**SUBDIVISION
SQUARE 2041**

**DEPARTMENT OF CONSUMER AND REGULATORY AFFAIRS
OFFICE OF THE ZONING ADMINISTRATOR**

Re: 3113 Albemarle Street, NW
Lot 0022, Square 2041, Forest Hills
Zoning Confirmation

RE: Z.C. Case No. 17-22 – Soapstone Valley Ventures LLC’s Application to the D.C. Zoning Commission for Review and Approval of a Consolidated Planned Unit Development and Amendment to the Zoning Map (Nov. 20, 2017)

SHEET TITLE
**BUILDING PERMIT SITE,
DC WATER, GRADING,
AND STORMWATER
MANAGEMENT PLAN
(NORTH PORTION OF SITE)**

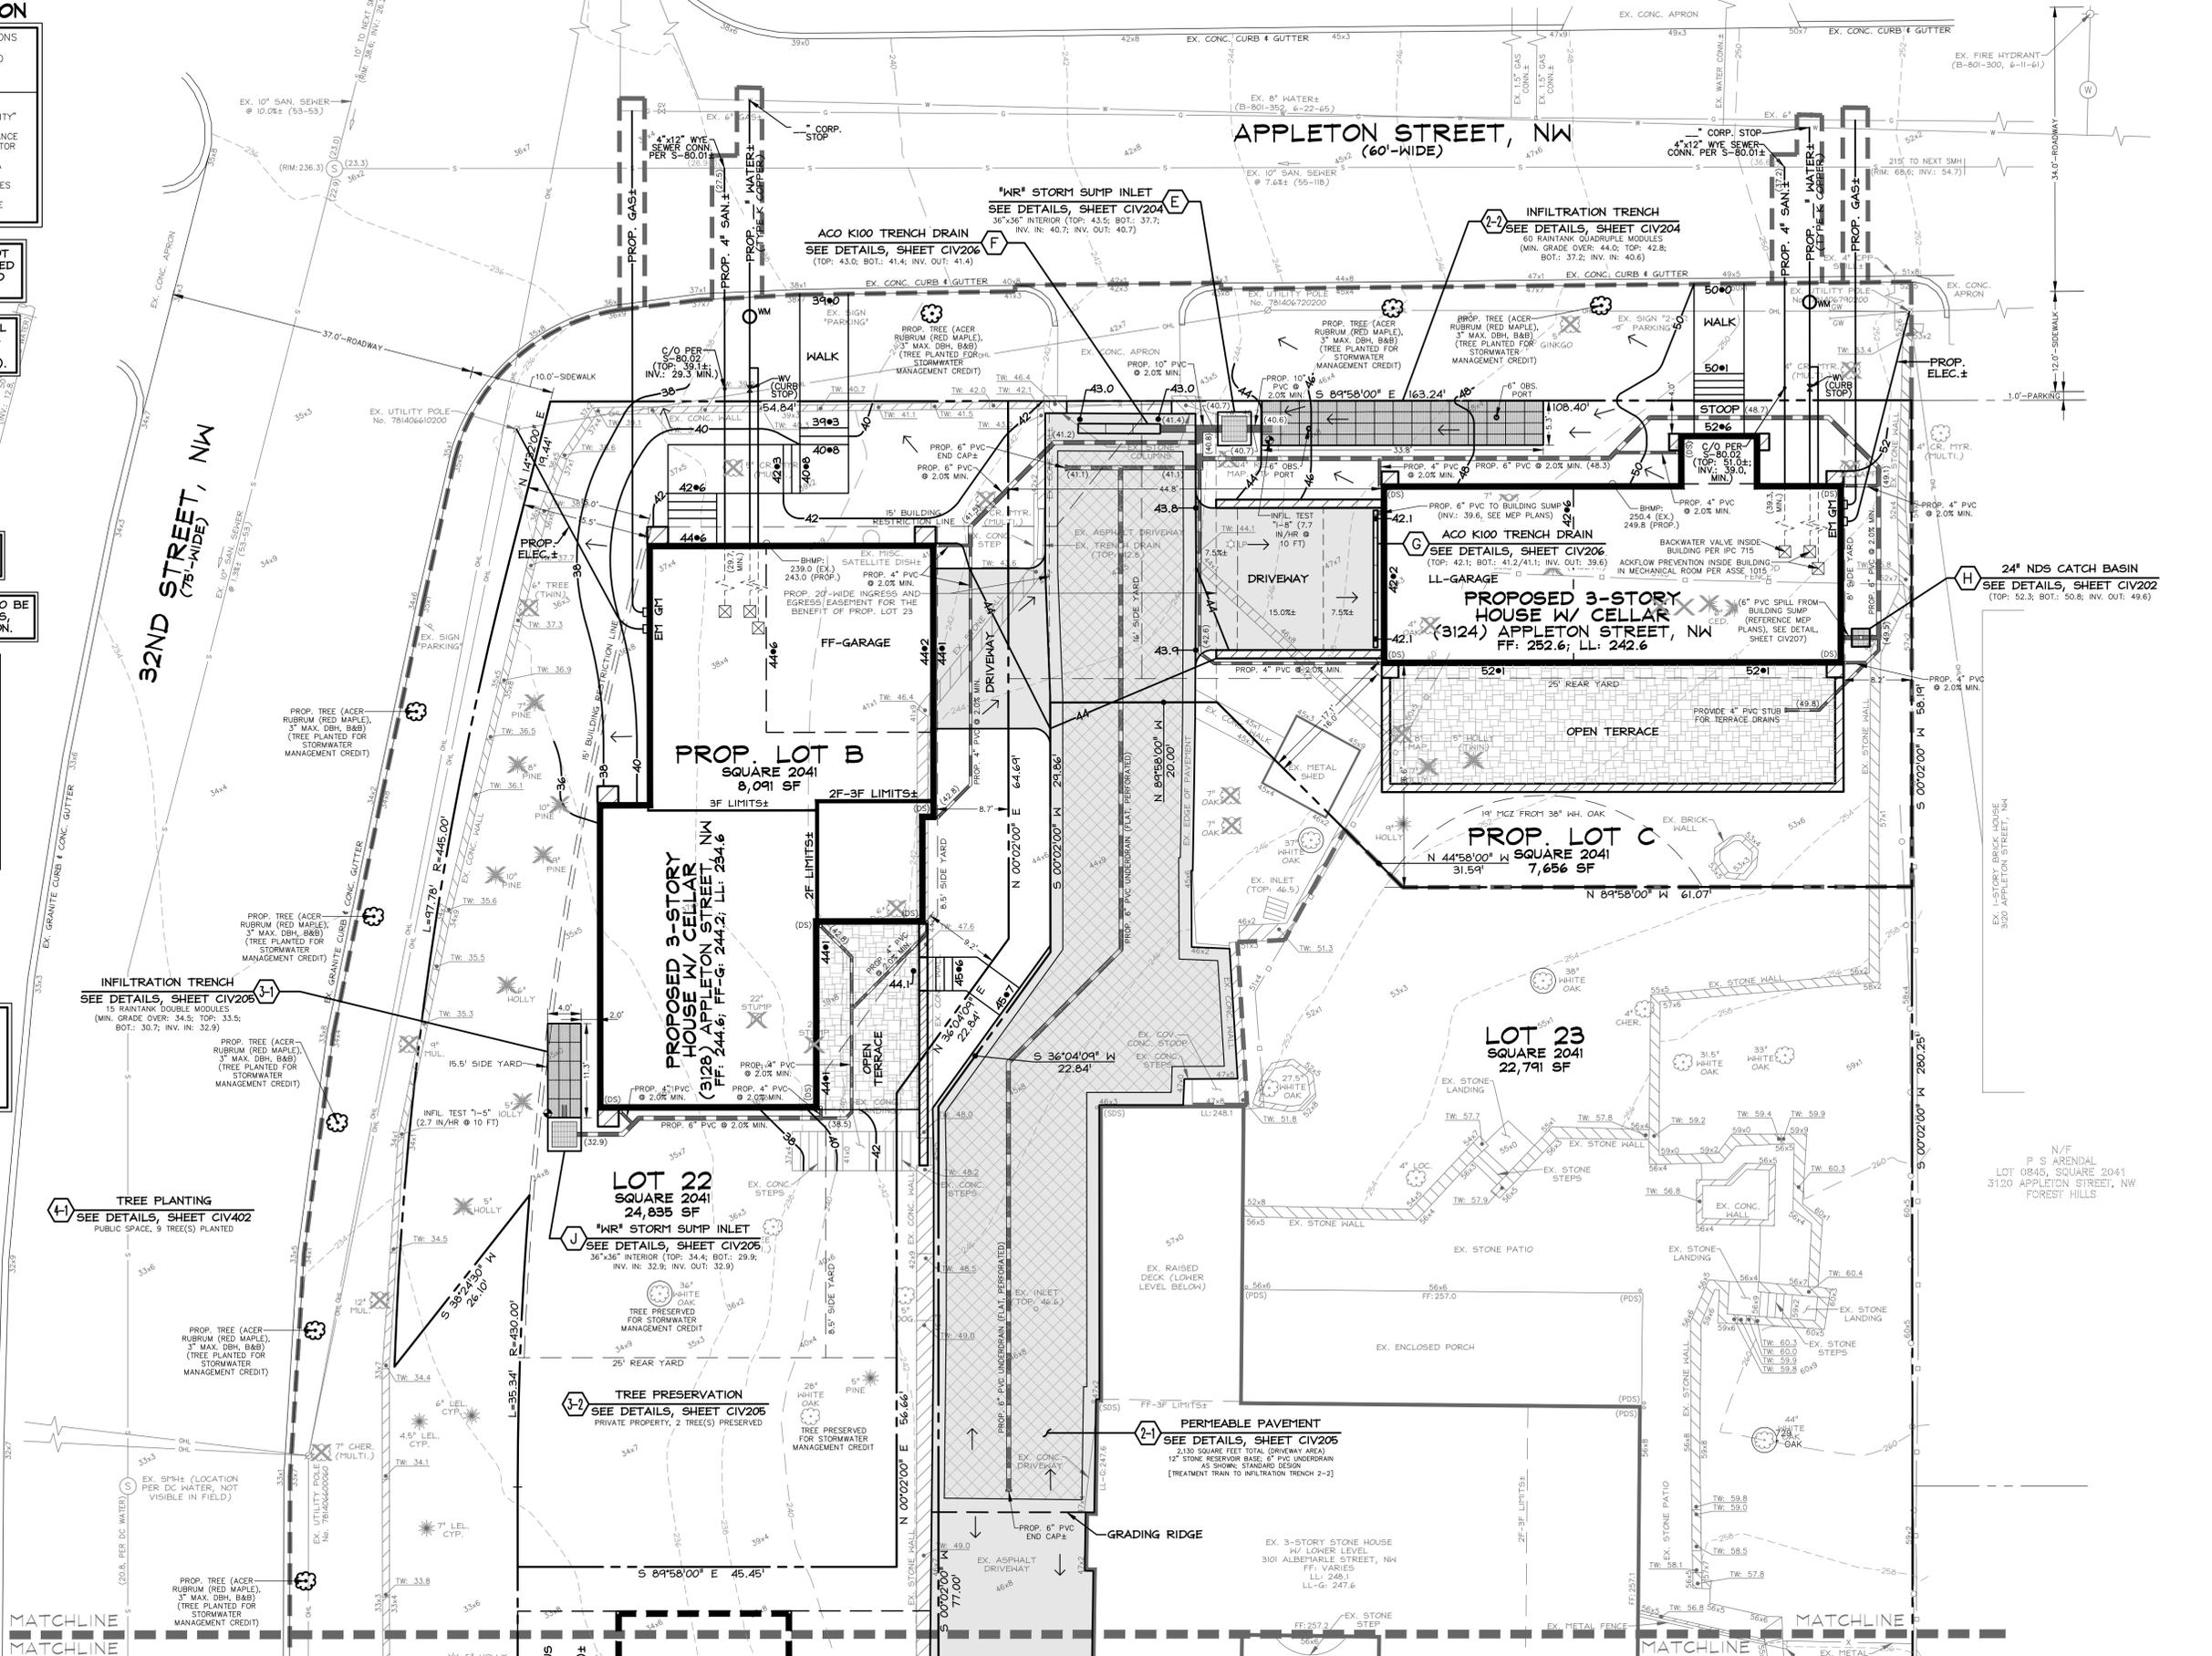
Ability to site a house on Lot 26, given Front Yard Setback requirements and Heritage Tree location: On page 2 --that is labeled CIV201 of the Attachment named "Concept Plans dated 4-20-2018.pdf" -- development of what is now Lot 26 is shown as "Proposed 3- story house with cellar". No building permit for that proposed development has yet been submitted to DCRA. As noted at the bottom of Page 1 of the letter, there is currently no front yard setback on Appleton Street but a front yard setback would be established depending on the timing or sequence of the development of Lots 25 and 26. At the time of a building permit application, compliance with the front yard setback provisions of the subject R-8 [Forest Hills] zine, under D-505.1 of the Zoning Regulations would be evaluated. In terms of possible impacts on a Heritage Tree, such impacts would be evaluated by the Urban Forestry Division of the District's Department of Transportation [UFD-DDOT]. I am cc'ing DDOT State Forester Earl Eutsler of that office so that he is aware of your concern.
